## Report Committee of Adjustment

**File:** A-2023-0149

**Address:** 37 Esker Drive

## Appendix A – Existing Site Conditions

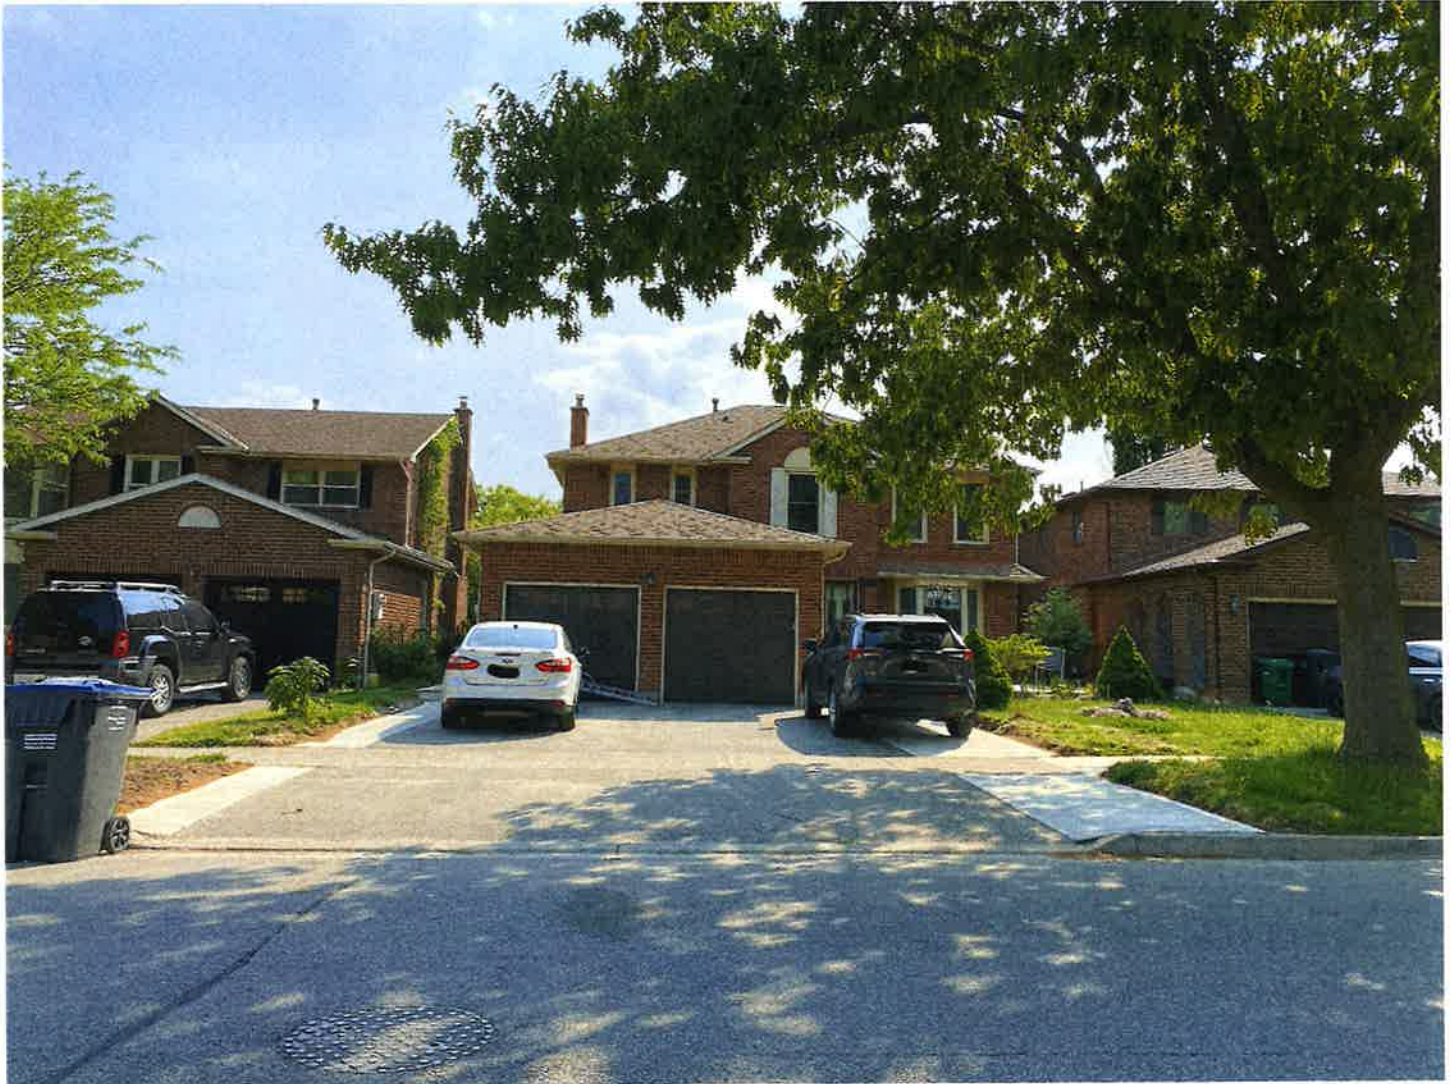
Staff recommend that the requested variance for an 8.89m (29.17 ft.) driveway width be refused, and that approval be based on the revised site plan provided by the applicant (Appendix B) showcasing a driveway width of 7.5m (24.61 ft.). The existing driveway was widened on both sides for a total width of 8.89m (29.17 ft.) which is 2.18m (7.15 ft.) wider than what the by-law permits. The widened portion of the northern end of the driveway leads directly to the main entrance of the dwelling and allows for several vehicles to be parked across the width of the driveway. As depicted in staff's site visit photos (Appendix A), this area is used to park an additional vehicle and, results in obstructions in the path of

travel to the front entrance of the dwelling. The current configuration of the driveway facilitated the parking of additional vehicles in an undesirable location and is considered excessive. As per review of the revised site plan provided by the applicant (Appendix B), the existing driveway width is proposed to be reduced by adding permeable landscaping on both sides of the driveway. The revised driveway width would be 0.79m (2.59 ft.) wider than what the by-law permits. Staff are of the opinion that the revised configuration of the driveway and reinstating landscaping at the northern portion of the driveway reduces the amount of hardscaping on site, does not allow an excessive number of cars to be parked in front of the dwelling, and provides a clear path of travel to the main entrance of the dwelling. Therefore, Staff recommend that the variance be refused, and that approval be based on the revised site plan provided by the applicant (Appendix B) showcasing a proposed 7.5m (24.61 ft.) driveway width.

# Appendix B – Revised Site Plan

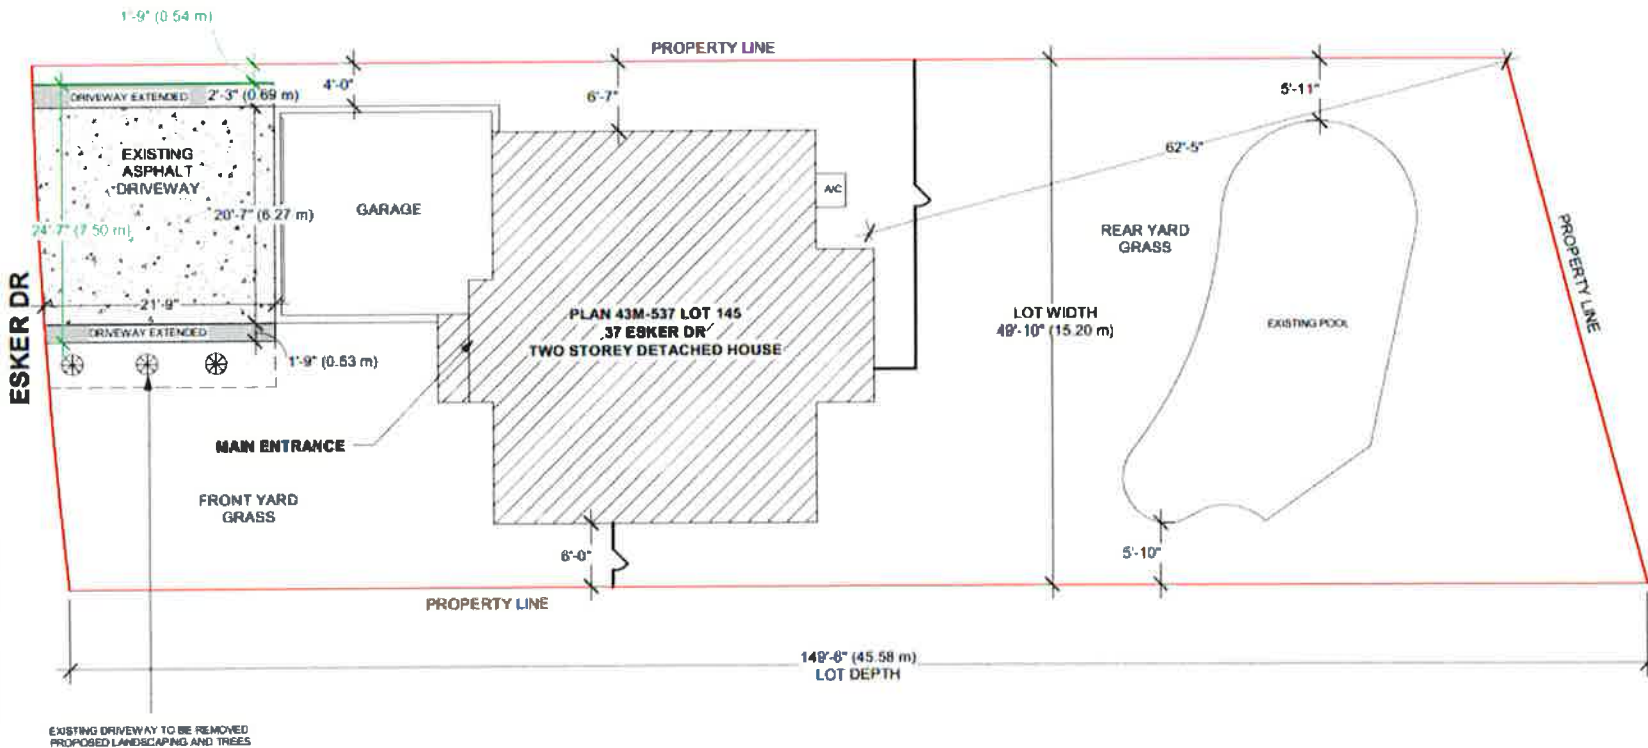
As depicted on the revised site plan, the applicant is proposing to remove 1.3m (4.27 ft.) of the northern portion of the paved driveway and provided landscaping. The variance requesting a revised driveway width of 7.5m (24.61 ft.) will not result in additional vehicles from parking in front of the dwelling and would be considered appropriate relative to the size of the property. Staff do not anticipate any negative impacts to drainage as permeable landscaping will be reinstated and will not result in the property being dominated by hardscaping. Furthermore, Open Space staff have noted concerns that the existing conditions and any further alterations to expand or alter the existing driveway may damage the existing street tree. The revised site plan (Appendix B) depicting a reduced driveway width minimizes impacts to the tree. Subject to the recommended conditions of approval, Variance 1, as revised, is considered to be desirable for the appropriate development of the land.

Given the revised driveway shape and configuration, the requested variance to permit an existing driveway width is not considered to facilitate an excessive number of vehicles to be parked in front of the dwelling. The revised configuration of the driveway results in permeable landscaping being reinstated which is not anticipated to have negative impacts on drainage nor will the property be dominated by hardscaping. Subject to the recommended conditions of approval, Variance 1 is considered to be minor in nature.

1. That the extent of the variances be limited to that shown on the sketch attached to the Notice of Decision;
  2. That Variance 1 to permit a driveway width of 8.89m (29.17 ft.) be refused. Staff recommend that approval be based on the revised site plan provided by the applicant (Appendix B) showcasing a proposed 7.5m (24.61 ft.) driveway width;
  3. The Owner must obtain a Road Occupancy and Access Permit from the City of Brampton's Road Maintenance and Operations Section for any construction of works within the City's road allowances.
  4. That failure to comply with and maintain the conditions of the Committee shall render the approval null and void.
-
